# ADDENDUM

**Project:** Tri County Public Schools HVAC  
Renovation Phase V

**Project No.:** 23-003

**Addendum No.:** 1

FLOOR PLAN - ELECTRICAL  
SCALE: 1/32" = 1'-0"

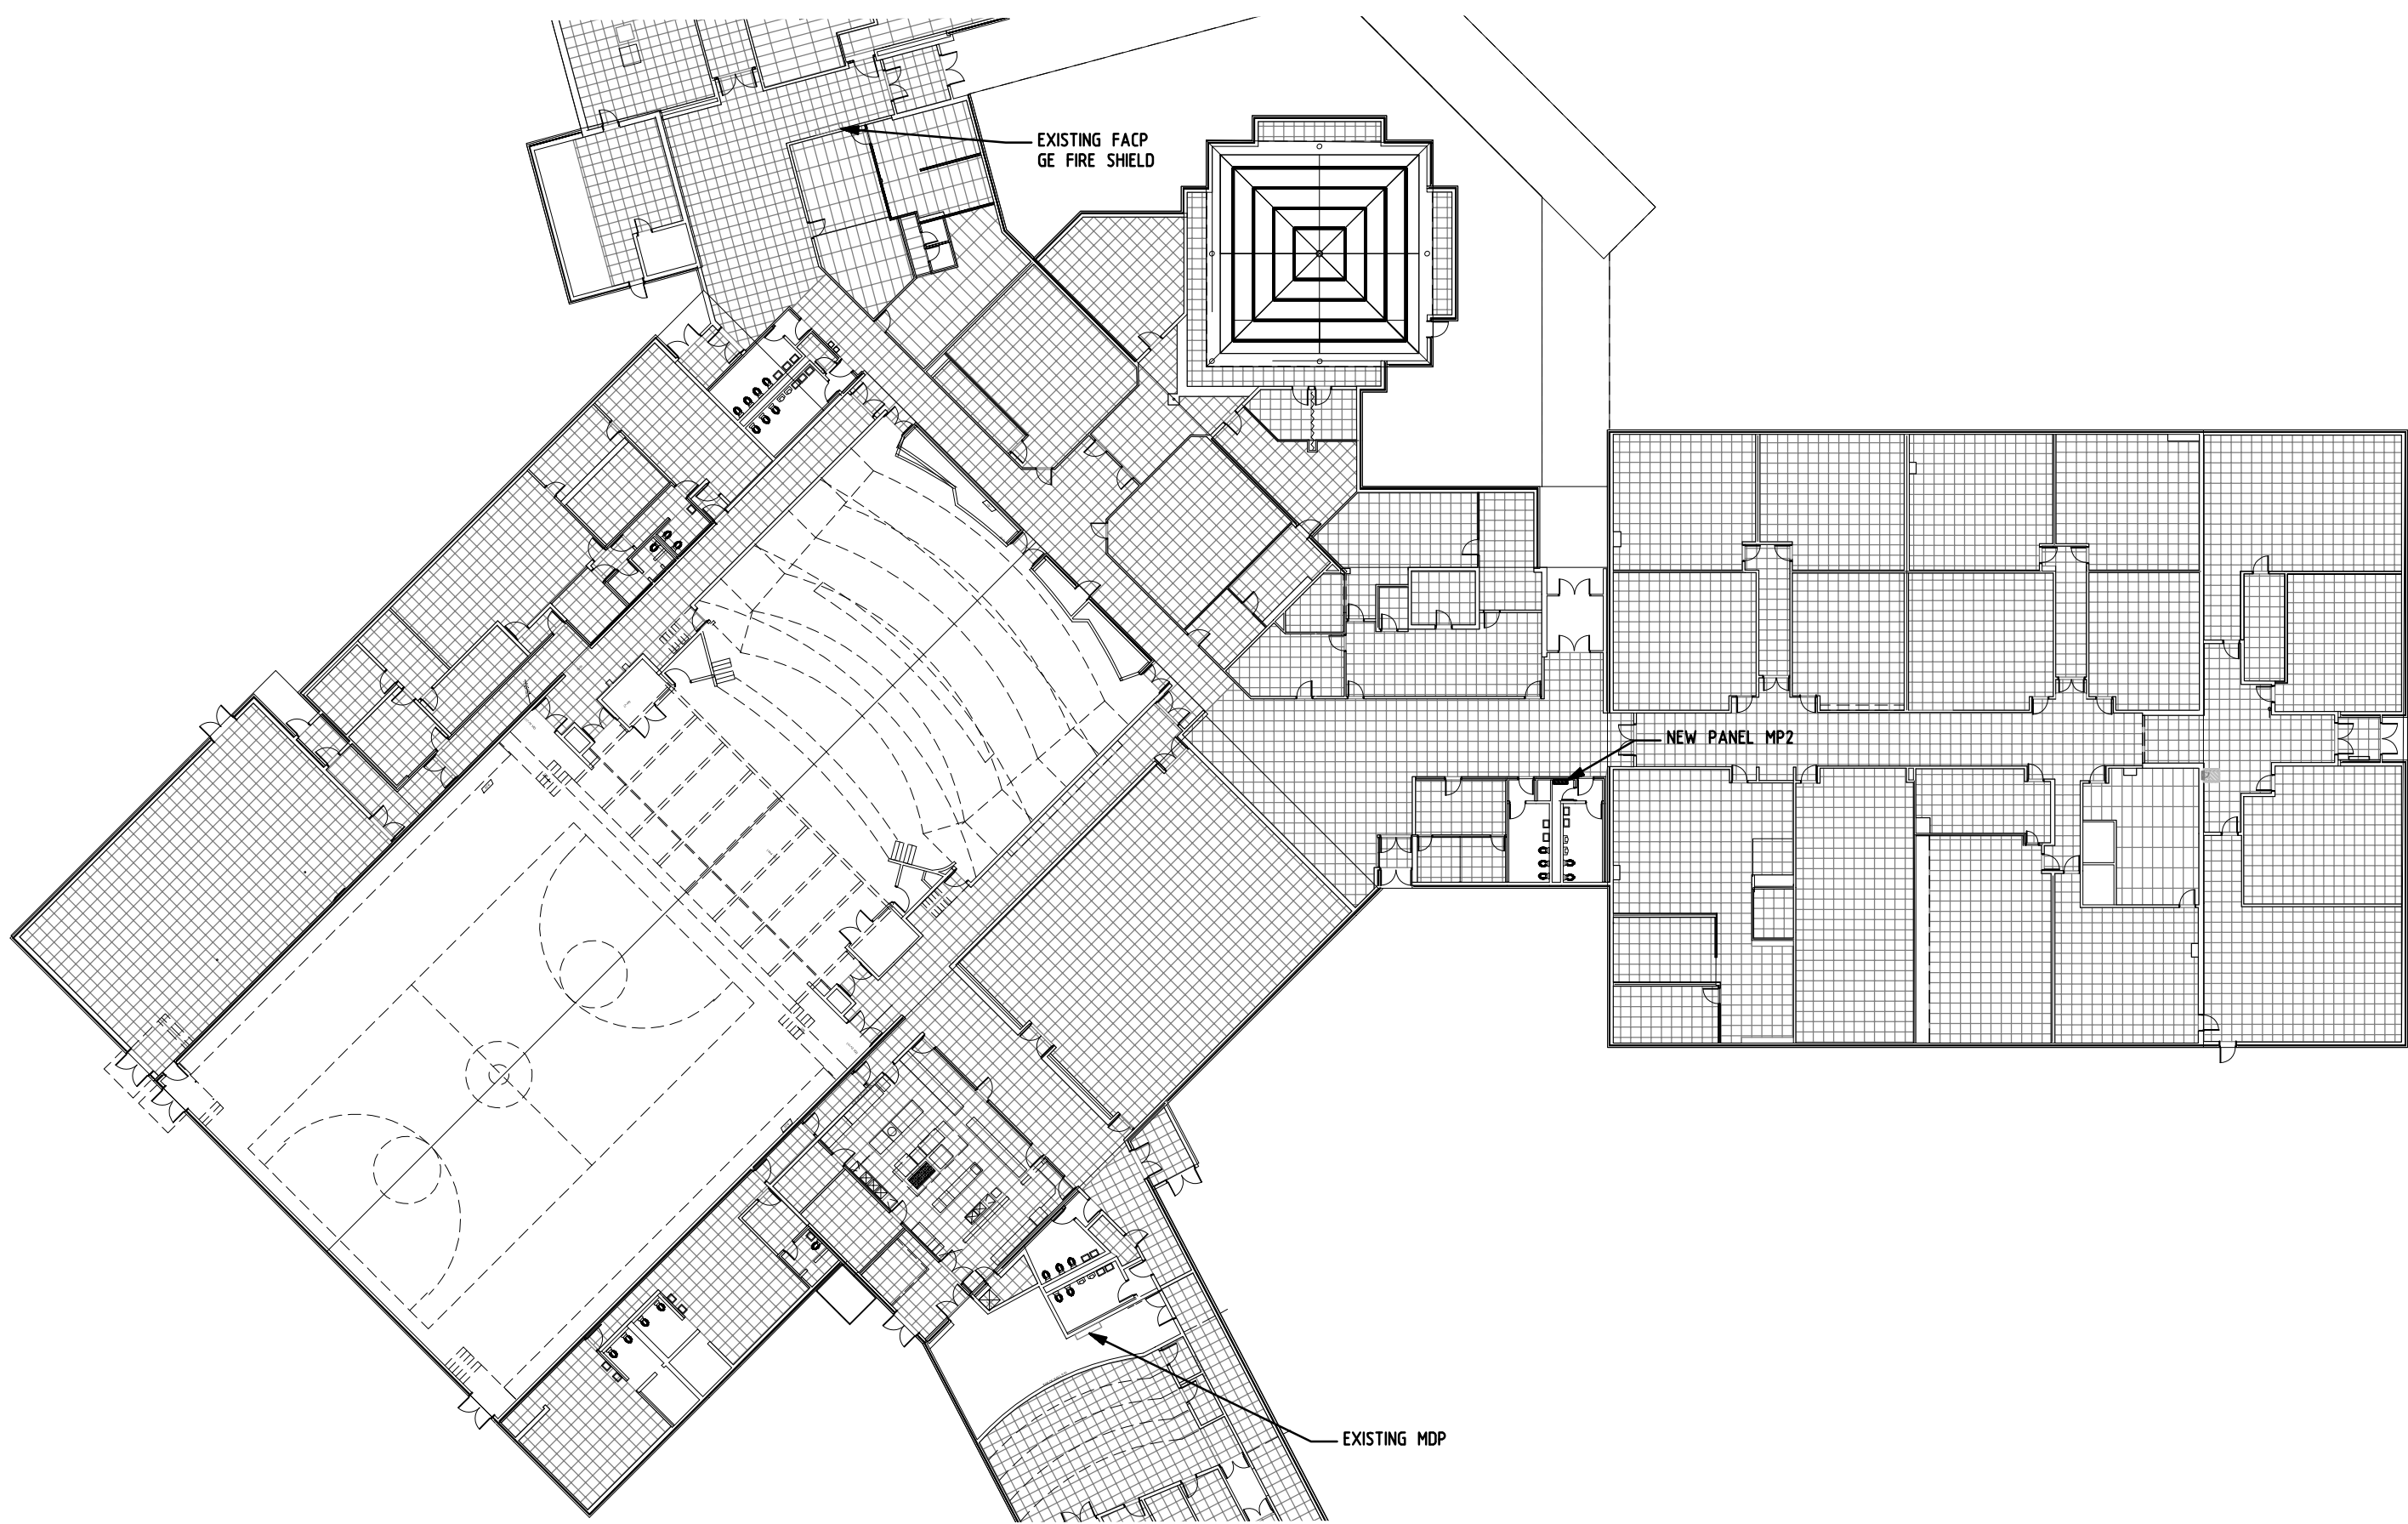
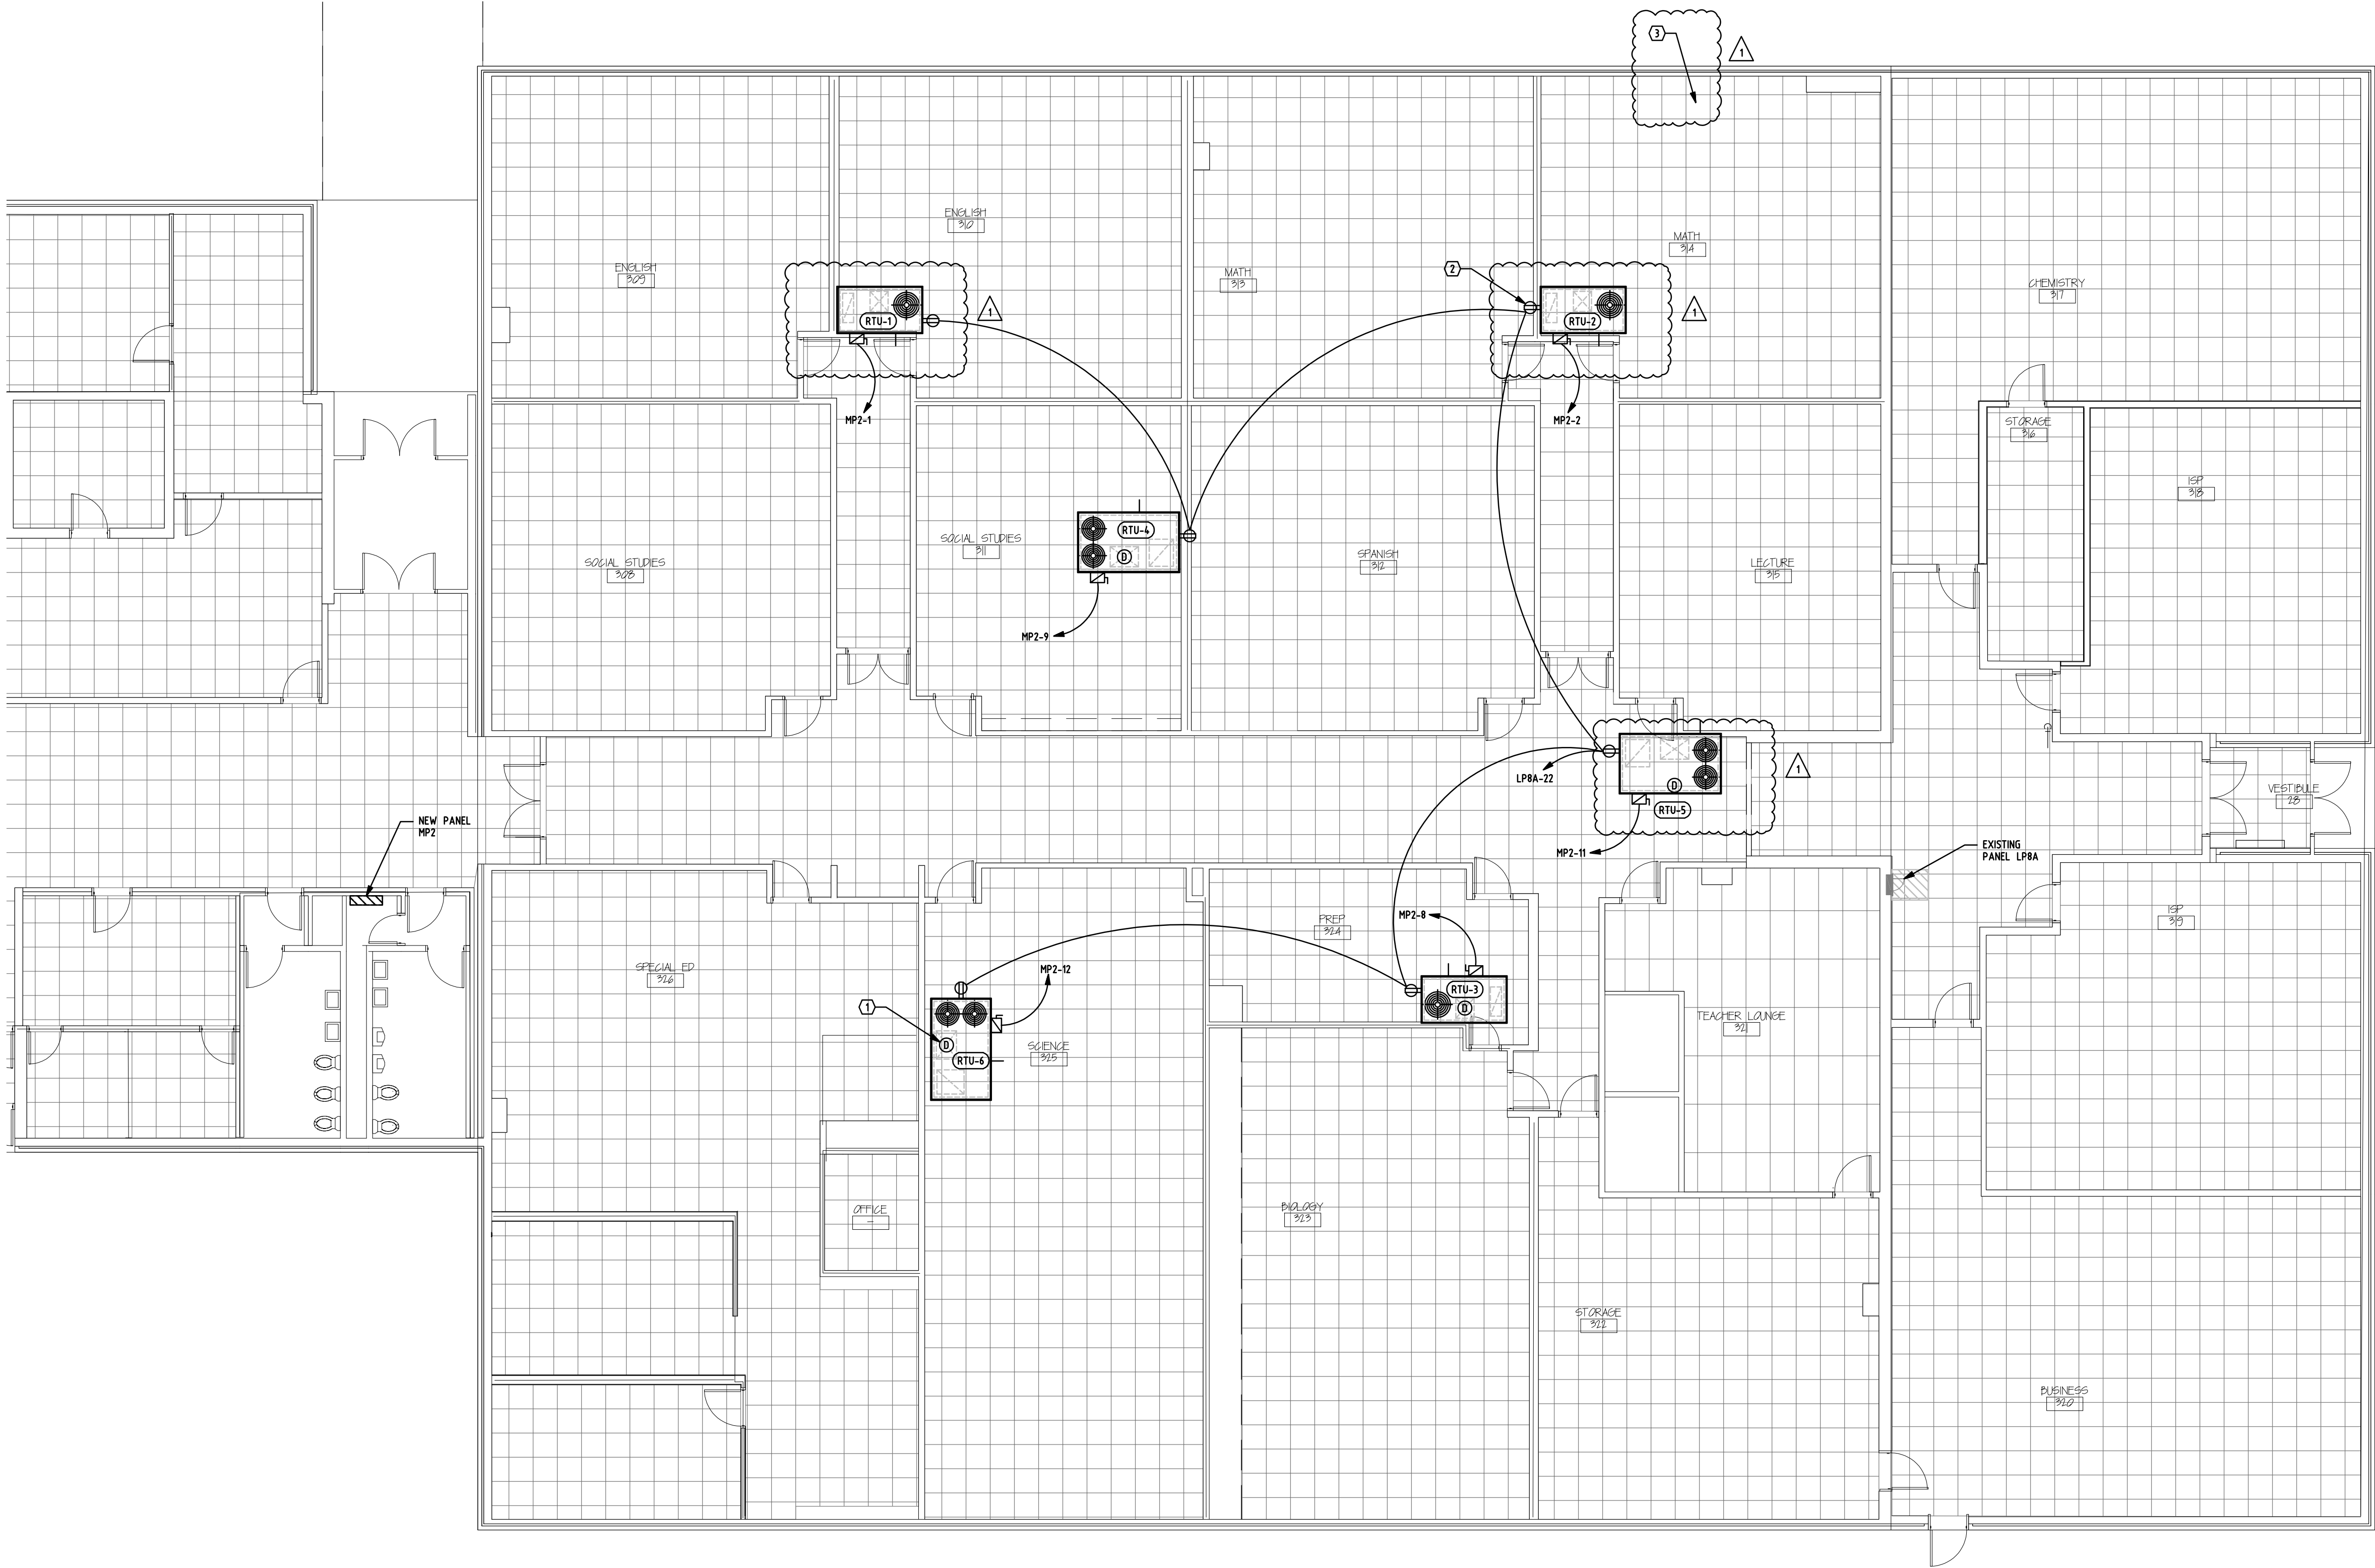
1. **E1.1 – Floor Plan – Electrical** – see attached drawing.
  - a. Adjusted connection to relocated RTU-5.
  - b. Removed duct detectors from RTU-1 and RTU-2.
  - c. Added key note 3. Electrical contractor to provide temporary support to electrical device in removed ceilings.

## ***E2.1***

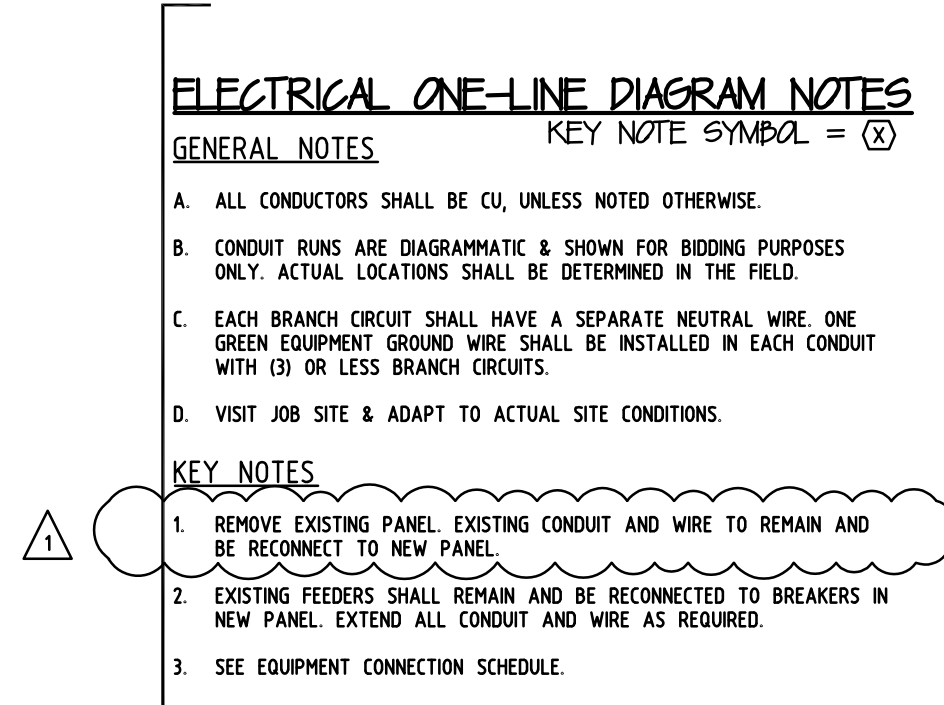
2. **E2.1 – Schedules and Details – Electrical** – see attached drawing.
  - a. Existing conduit feeding new panel MP2 to remain and be re-used.
  - b. Panel Schedule for existing panel LP8A added to the sheet.
